Technical *Info*

Changing the CT 909 K5 timing belt kit for VW/Audi/Skoda/Seat 1.8 T/2.0 to the CT 909 K10

(Change from hydraulic tensioning damper to mechanical tensioning pulley)

Fig. 1
Version to be replaced

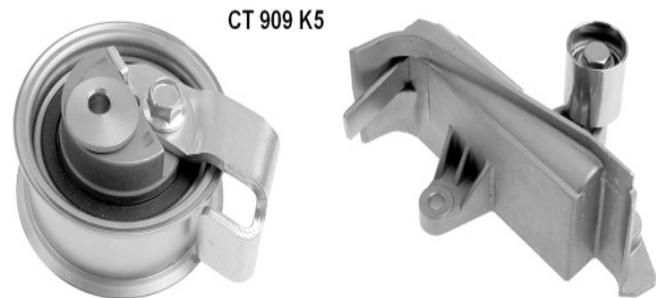
The components supplied in the timing belt kit do not match the components previously installed on the vehicle (Fig. 1).

According to the OE manufacturer there is a new tensioning system with a mechanical tensioning pulley for the relevant vehicles specified in the catalogue. In this, the hydraulic tensioning damper with the small idler is replaced by a new version with just one bracket for the idler (Fig. 2).

After fitting the timing belt and the bracket with the small idler, set the tensioning pulley to the mark by turning the eccentric clockwise (Fig. 3). Check the setting after cranking the engine twice. Tighten the nut of the tensioning pulley to a torque of 23 +/- 3 Nm.
